LiDAR Quality Assessment Report

Territory of Guam

Guam_2012

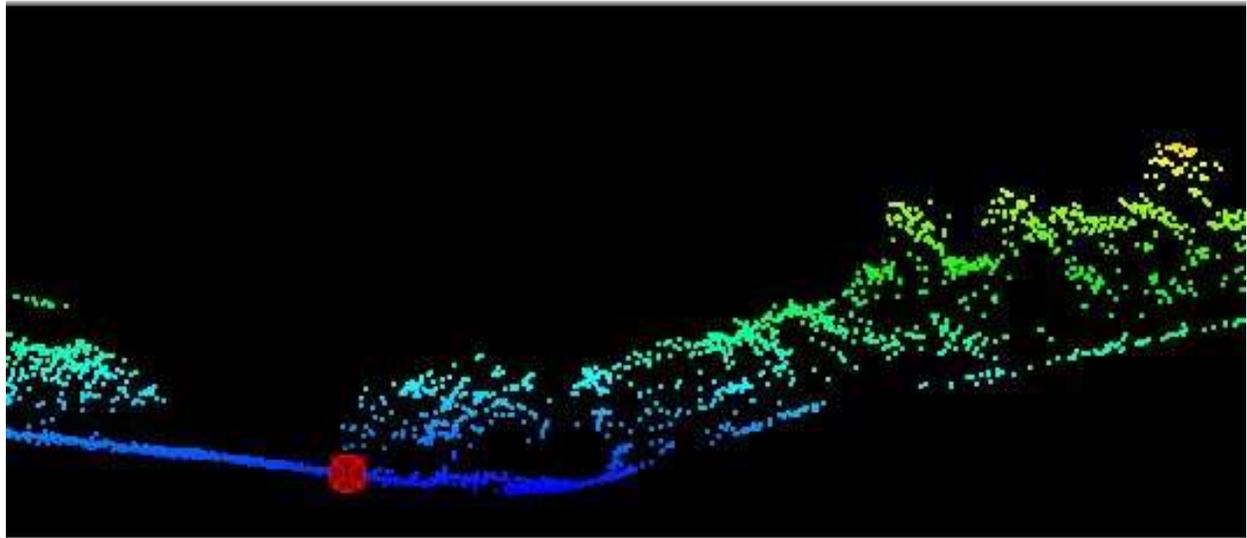
Check point 204: Removed from the vertical accuracy assessment for Swath FVA. This point is located in an area with tree cover; it has a z-error of -0.719 meters which indicates that the survey ground elevation is 0.719 meters less than the swath LAS TIN surface elevation.

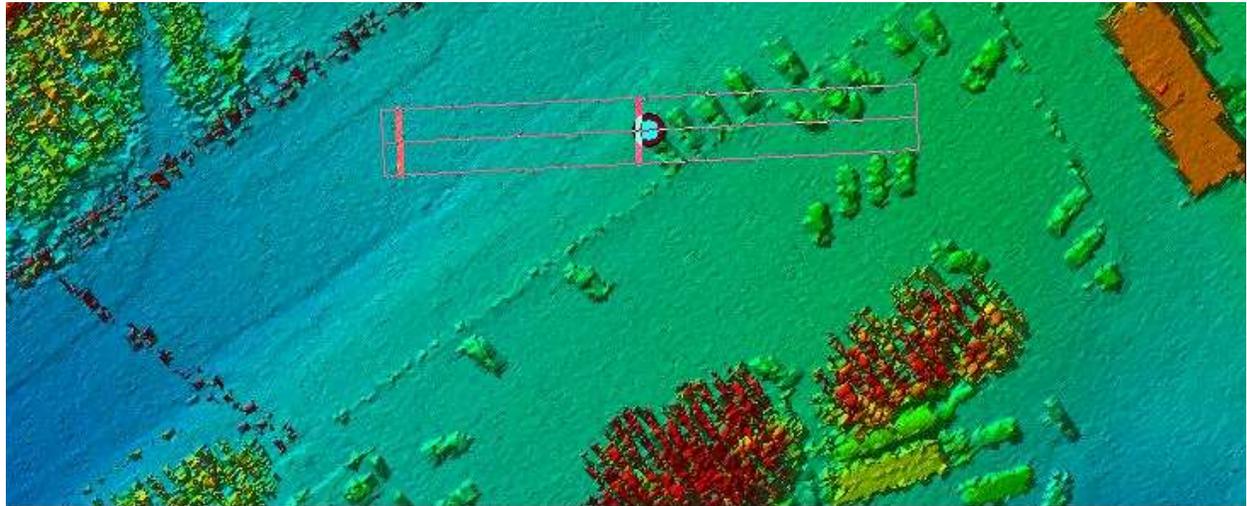
Check point 207: Removed from the vertical accuracy assessment for Swath FVA. This point is located in an area near a vehicle; it has a z-error of -1.007 meters which indicates that the survey ground elevation is 1.007 meters less than the swath LAS TIN surface elevation.

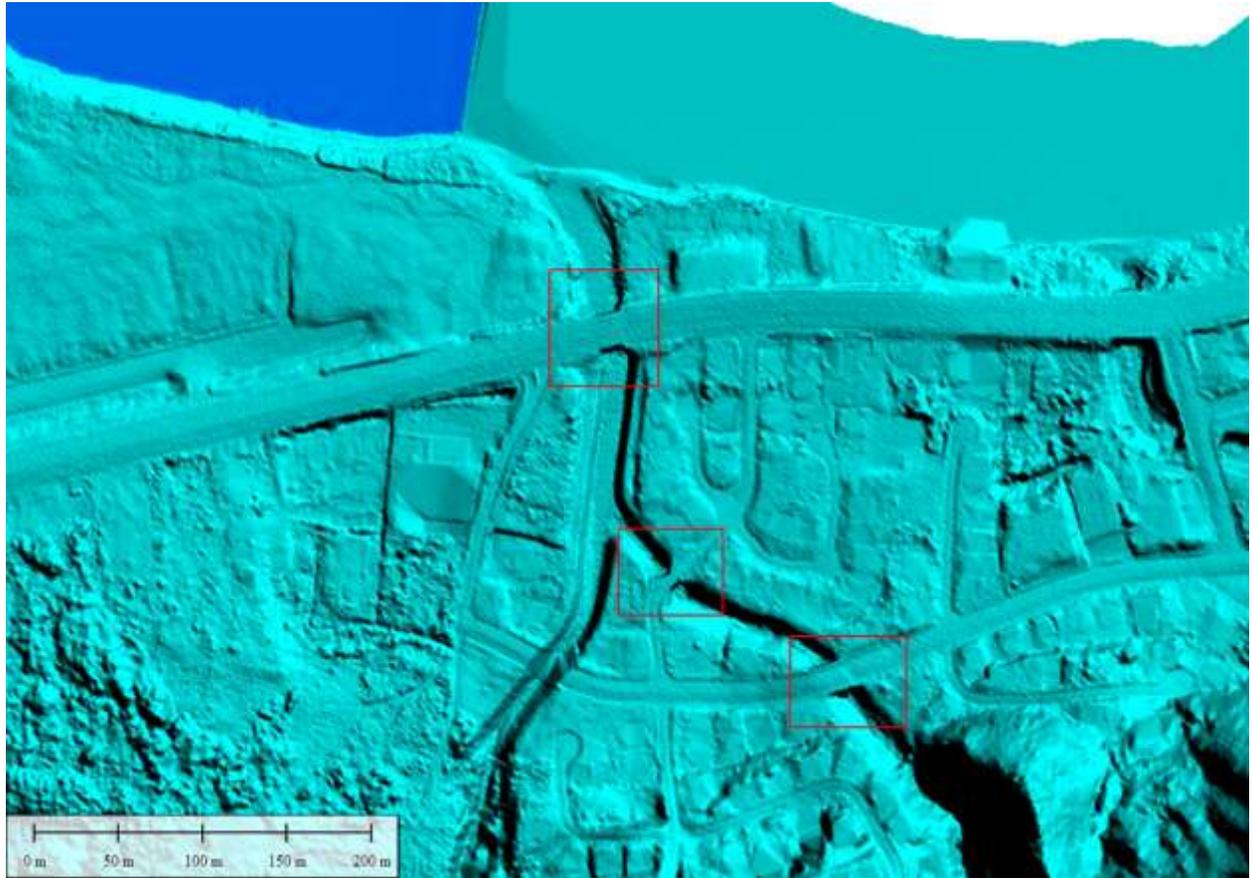
incomplete_bridge_removal_1: The roadway (bridge) over the waterway is not completely removed. There are two of this error-type.

**Error fixed by contractor... (9/12/2013)

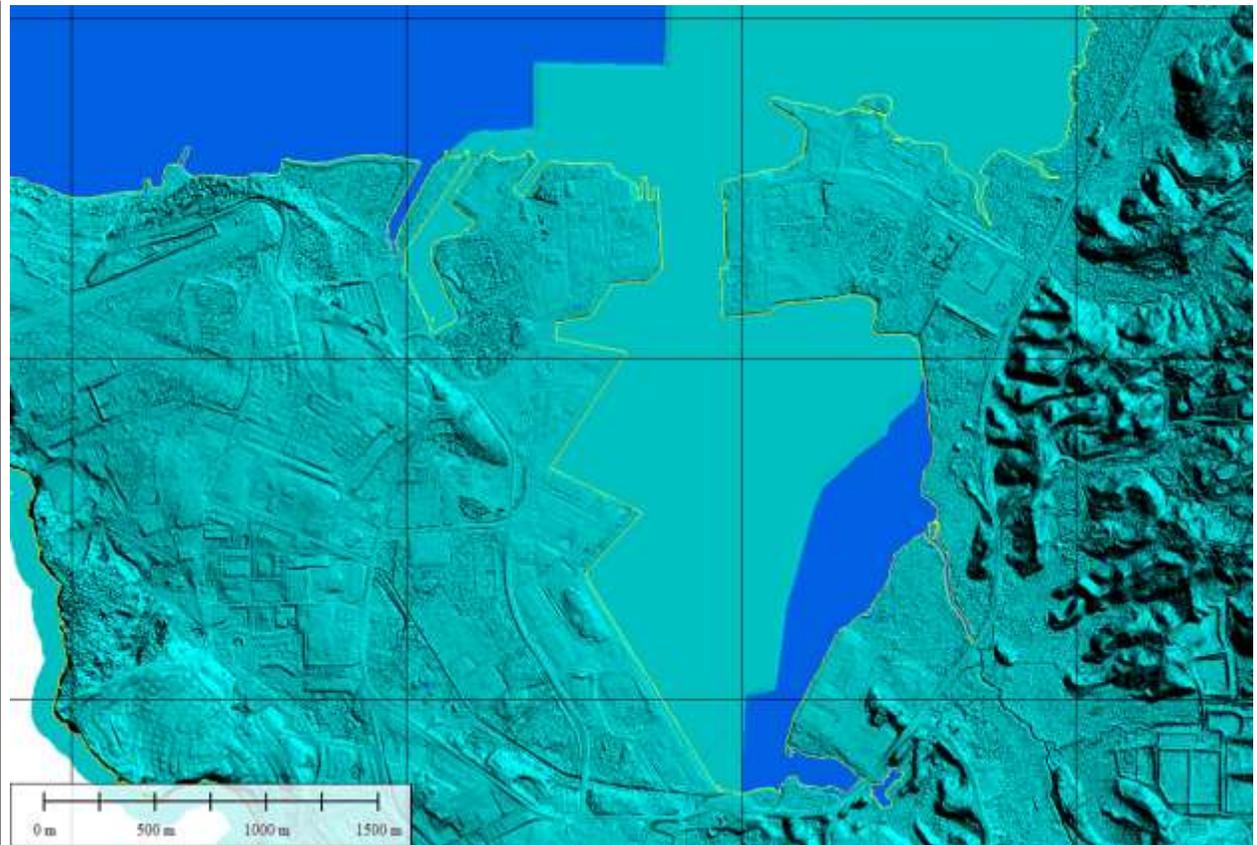
bridge_1-3: Roadways (bridges) over the waterways have not been removed; these are interpreted as bridges and not culverts. There are five of these error-types... three are represented in this image.

**Error fixed by contractor...(9/12/2013)

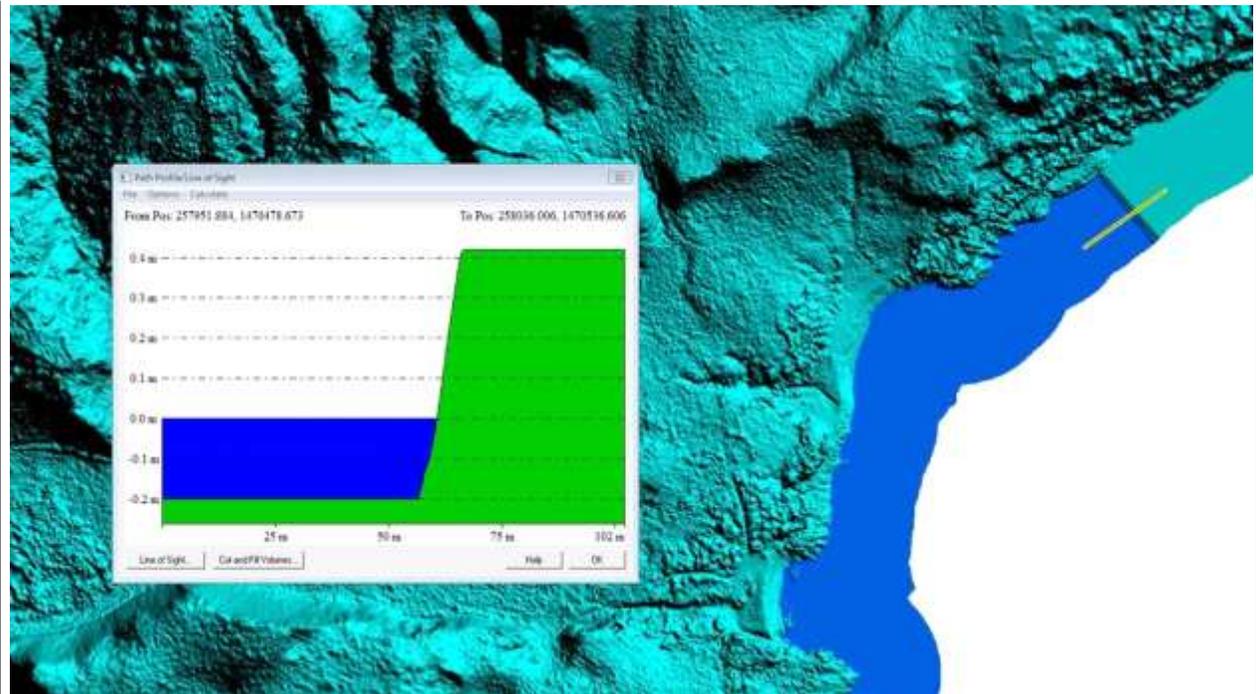
near-shore_water_elevation_differences: Water levels located on the shore of the entire project contain different elevations.

**Error not corrected by contractor; see Internal Notes for details...(9/12/2013)

All errors corrected by vendor except the water 'elevation' issues around the coastline of entire island. This lidar was collected over 1.5 years thus tidal variations resulted in irregularities within the coastal regions. According to NGP, USGS Lidar Base Specifications Version 1.0, notes:

- Tidal variations over the course of a collection or between different collections, will result in lateral and vertical discontinuities along shorelines. This is considered normal and these anomalies should be retained.
- Water surface is to be flat and level, to the degree allowable by the irregularities noted above.

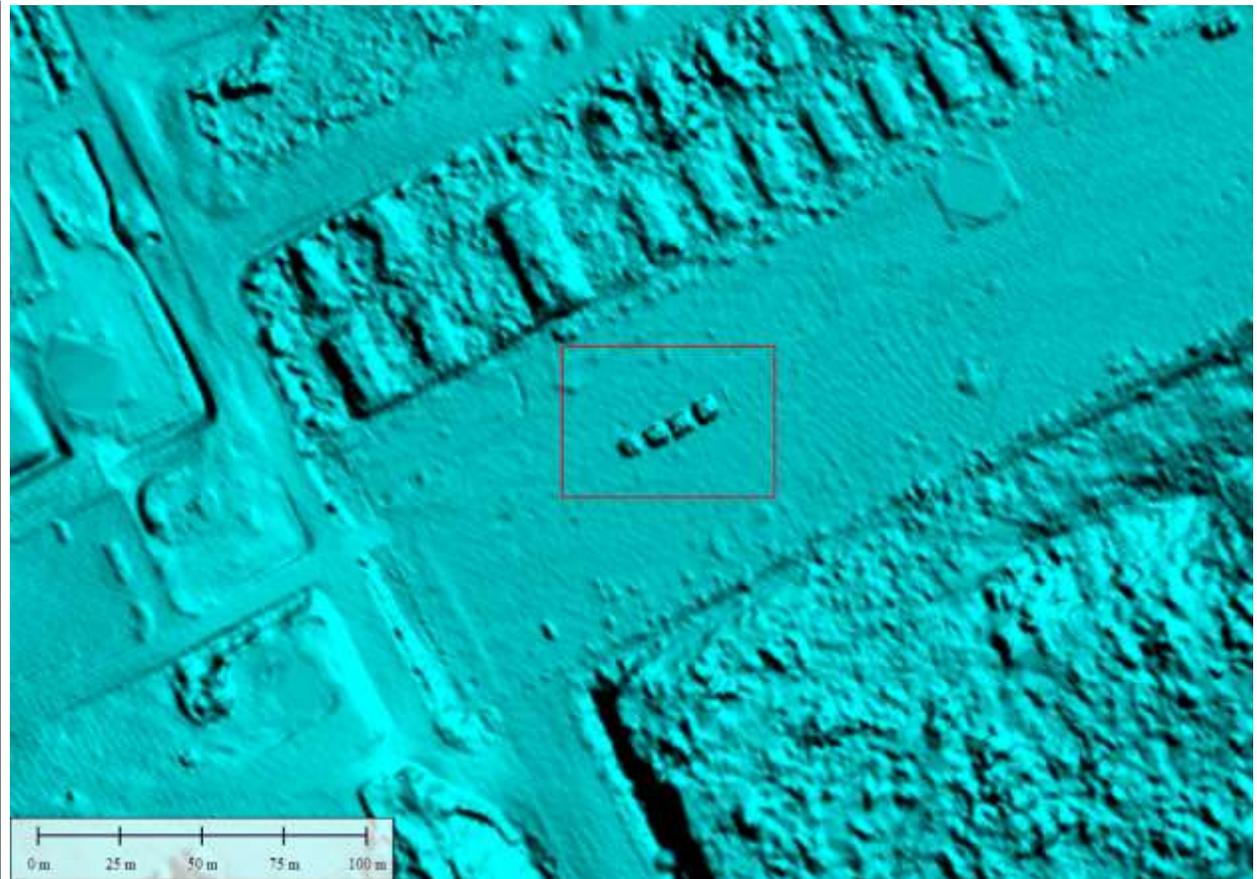
surface_elevation_change: The yellow line is the location of the cross-section in the inset image. This near-shore water level difference is another example of the error-type mentioned in the previous image. This error-type is prevalent around the entire project....but only along the shorelines..not inland ponds/lakes.

**Error not corrected by contractor; see Internal Notes for details...(9/12/2013)
